DATE: October 13, 2011
TO: Historic Preservation Commission
FROM: Tim Frye, Preservation Coordinator
RE: 49 Julian Avenue
Case No. 2005.0233C

49 Julian Avenue

San Francisco Armory Restoration
and
49 Julian proposed development

Shadow Model, shows 49 Julian as planned, The Armory, and the 1880 Mission St project (currently being built)

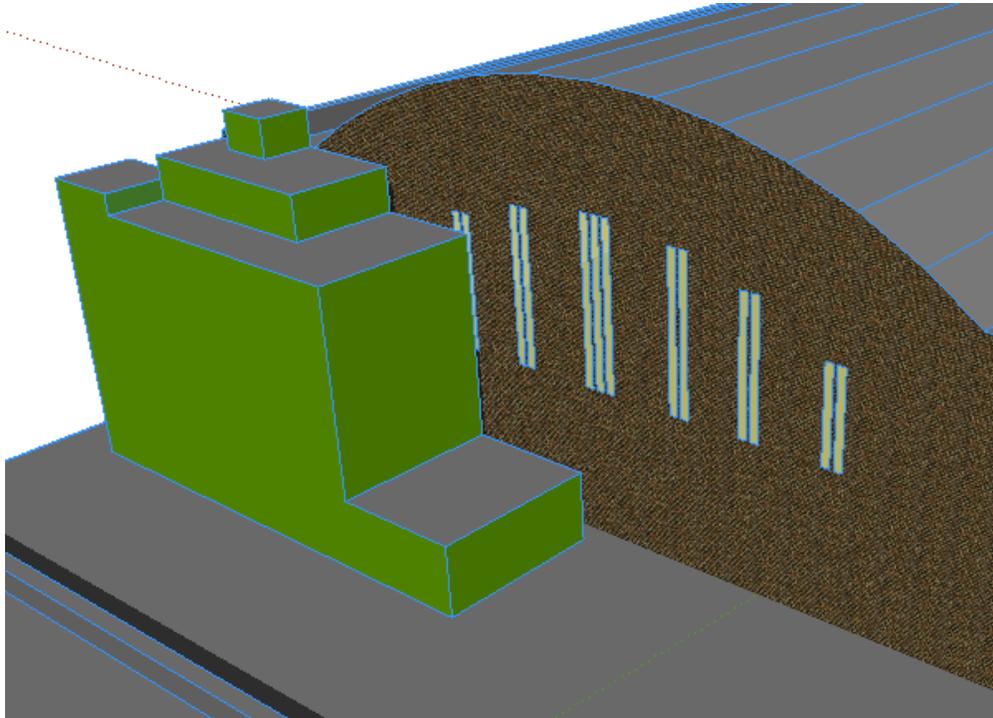
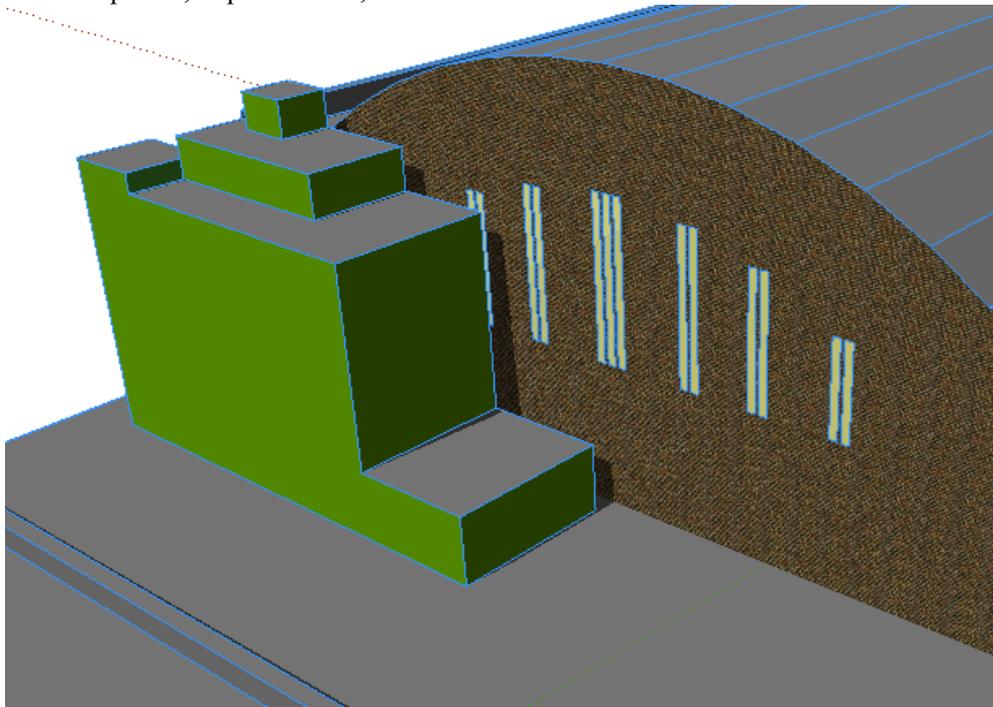
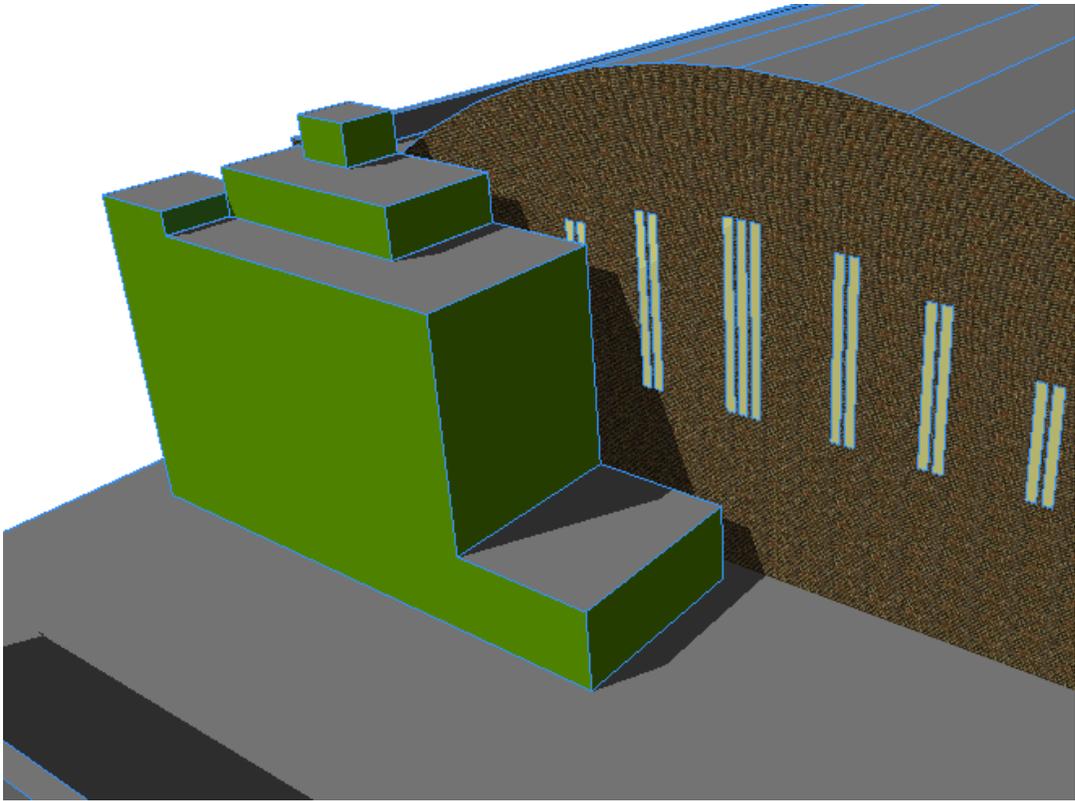
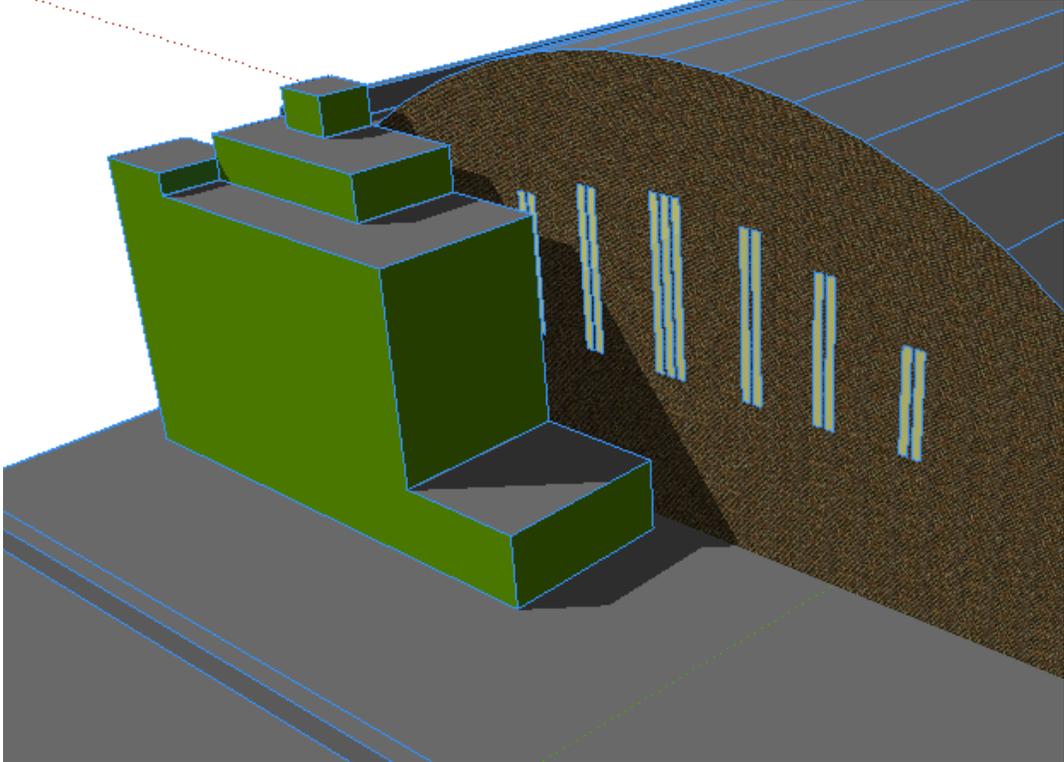
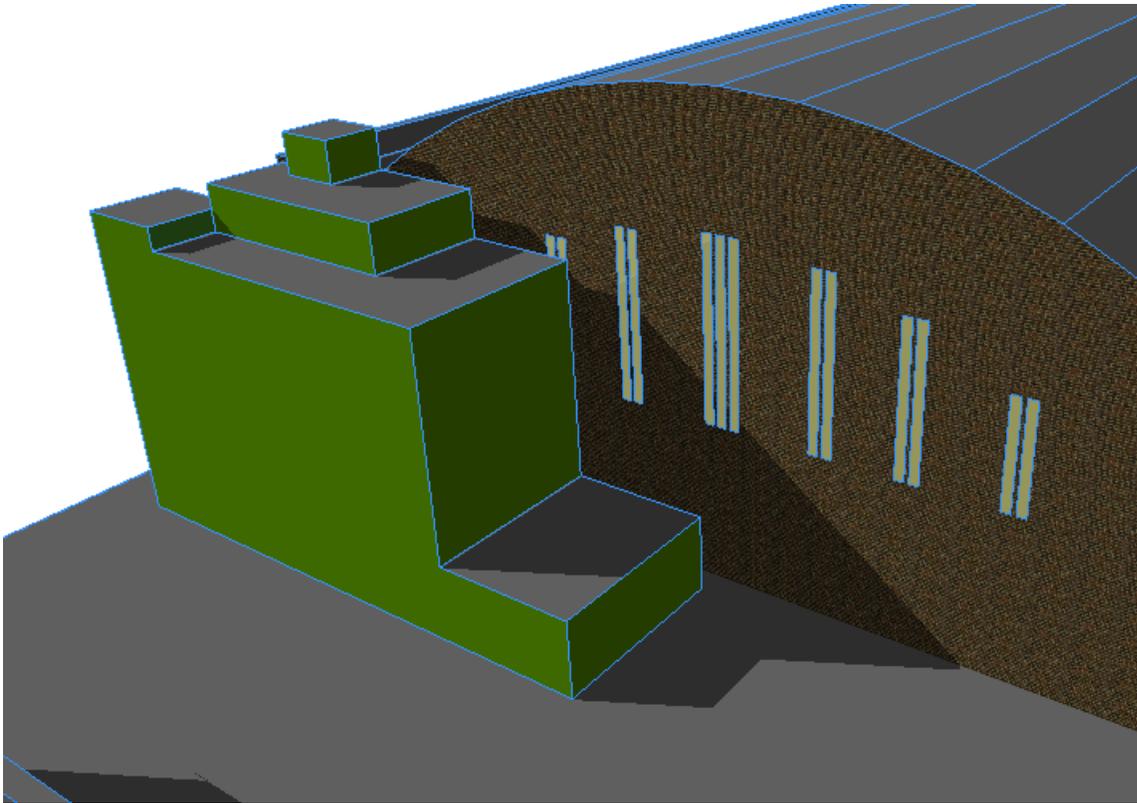
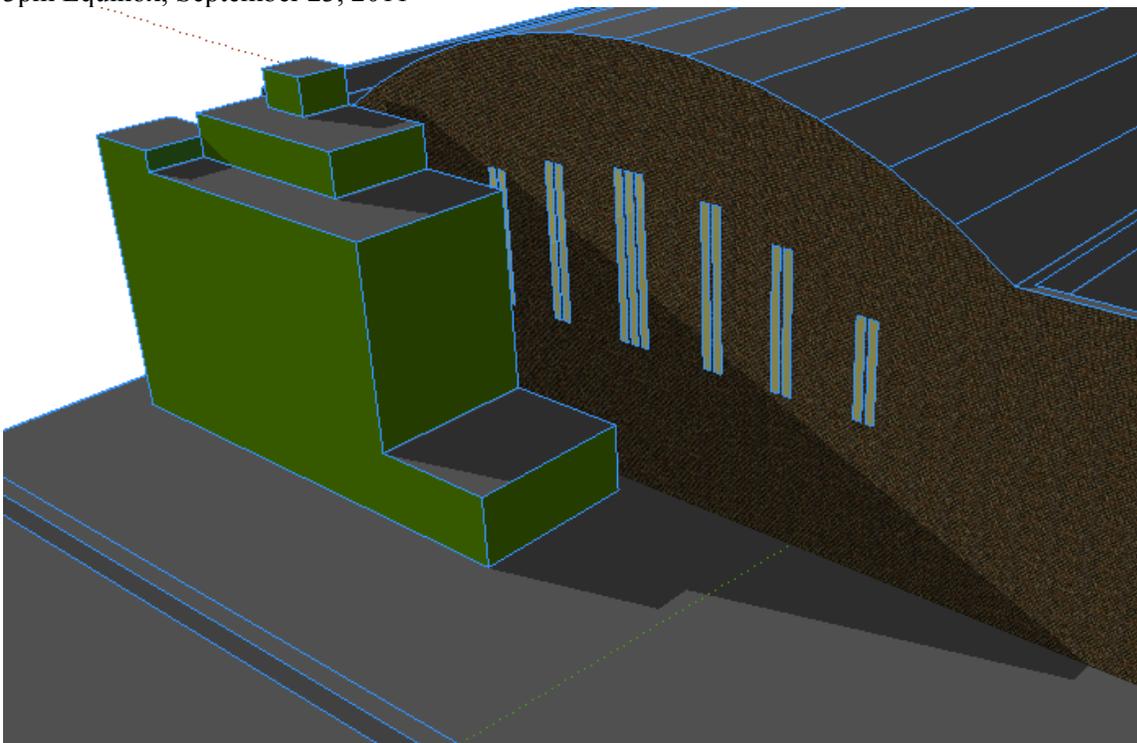
Issue #1 Loss of Light

This section aims to demonstrate the impact to light to the historically and architecturally significant south facing curved windows in the Drill Court.

This issue would be partially mitigated if 49 Julian were to adhere to the current UMU zoning, which would require the structure to be 45 feet tall, as opposed to the currently planned, 50' development.

View from Julian Avenue as designed under grandfathered C-M zoning (building height 50').

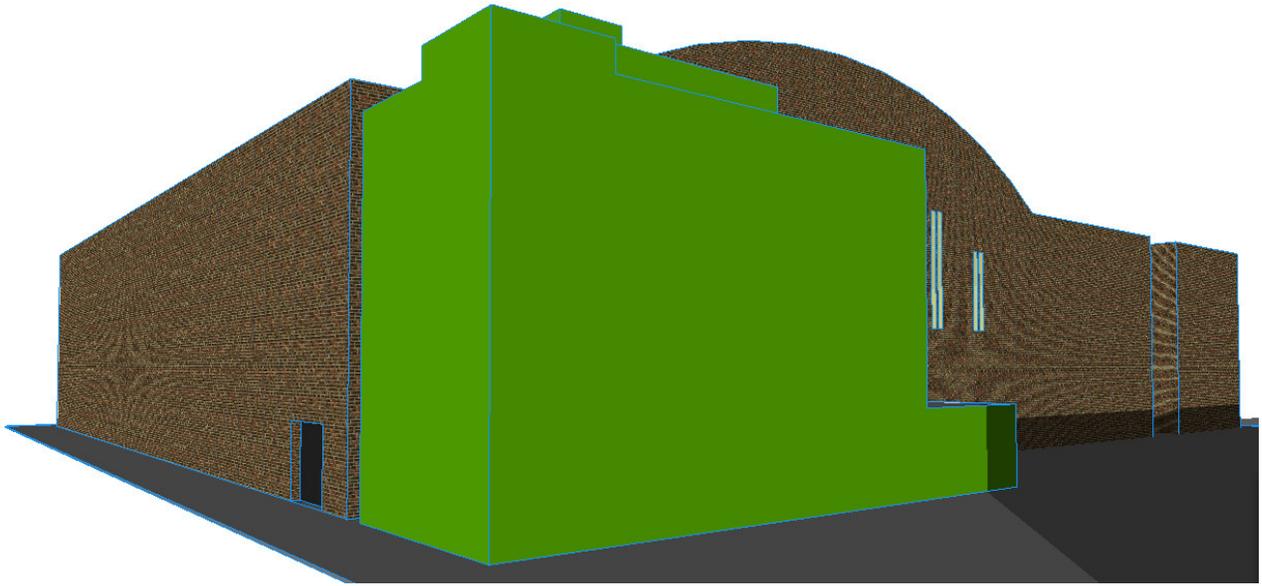
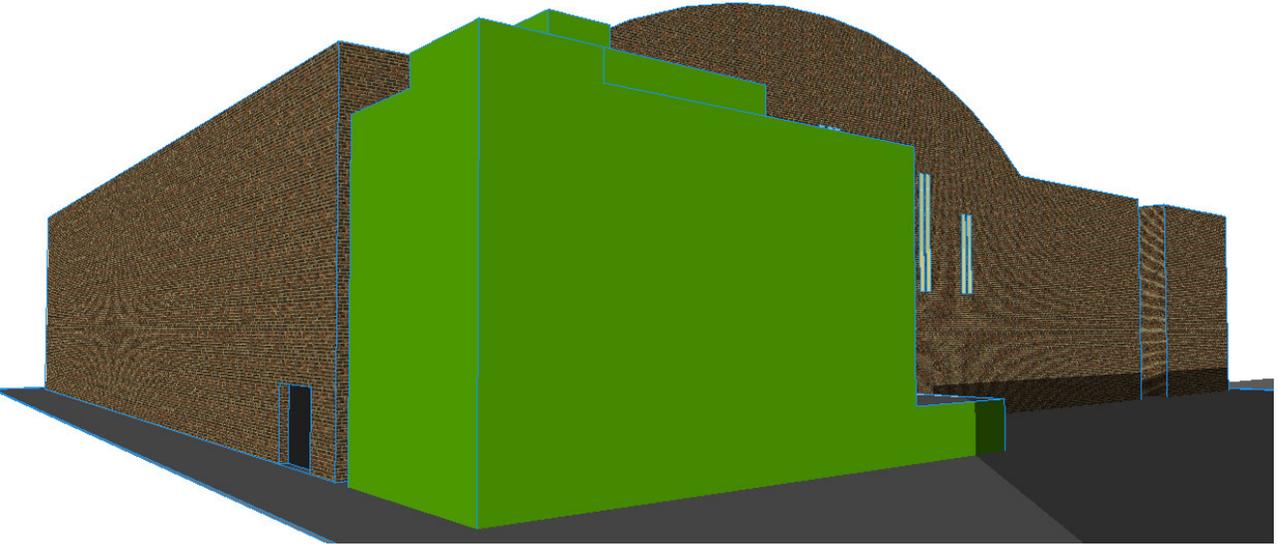
Issue #2 Obfuscation of signature curved roof of the Armory from the exterior

The Signature curved roof of the Armory is impaired by the development of 49 Julian, as proposed. *This issue would be partially mitigated if the development adhered to the UMU, as the height limit would be reduced from 50' to 45'.*

View from Julian Avenue as designed under UMU zoning (building height 45').
